# Technical Service Bulletin

## 21 Mil on (DTC P0299 - negative pressure deviation); turbocharger excessive wastegate play

21 13 16 2031245/6 July 9, 2013. Supersedes Technical Service Bulletin Group 21 number 13-14 dated June 7, 2013 for reasons listed below.

**Figure 2.** Fit the clip from the side.

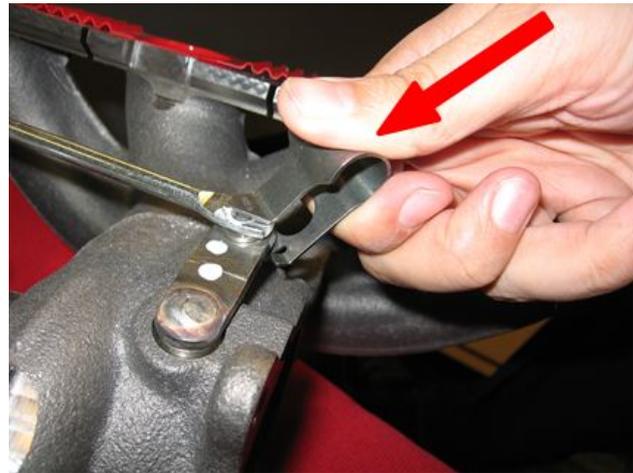
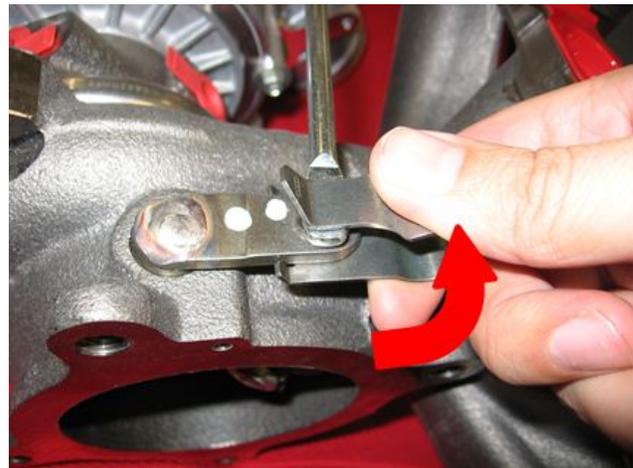
3. Install clip **06J145220B** on a new, replacement turbocharger's link plate and actuating rod joint as illustrated (Figures 2 and 3).

**Figure 4.** (1) Maximum opening of clip, (2) Position of original circlip

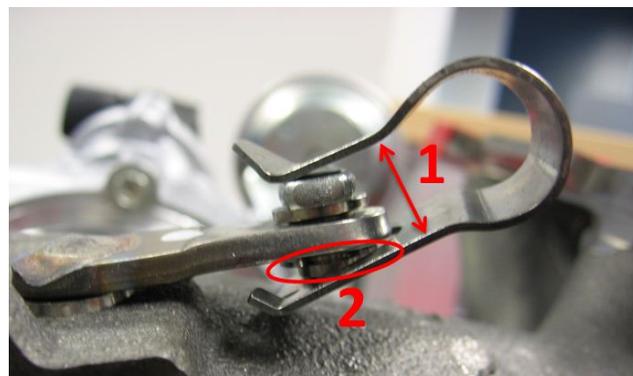
- The spring clip must not be overstretched. The maximum opening of the spring clip is 14 mm (Figure 4, 1).
- The spring clip must be replaced after every removal.

**Figure 5.** Correctly-fitted clip.

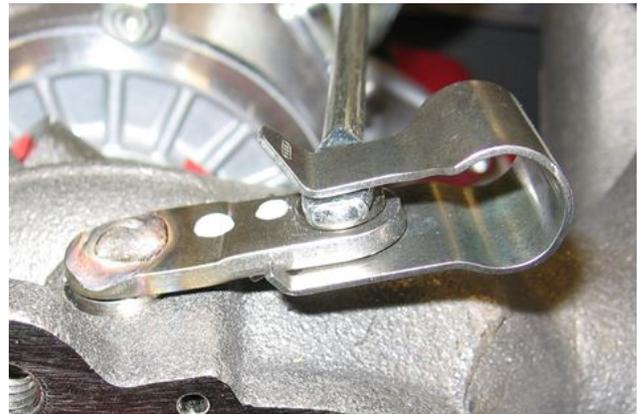
5. After fitting the spring clip, check for correct fit (Figure 5).

**Figure 6.** (1) Maximum opening of clip, (2) Position of original circlip

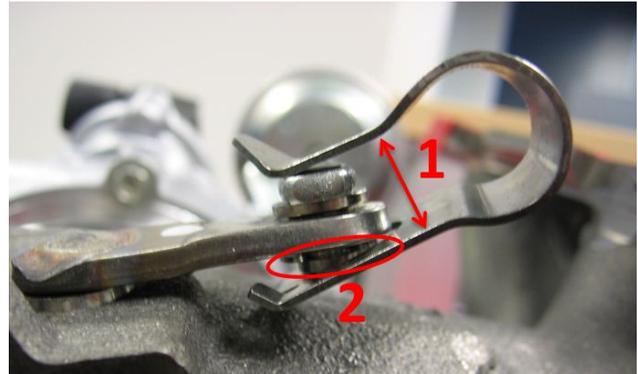
6. After fitting the spring clip, check the position of the original circlip (Figure 6, 2) and correct it if necessary.
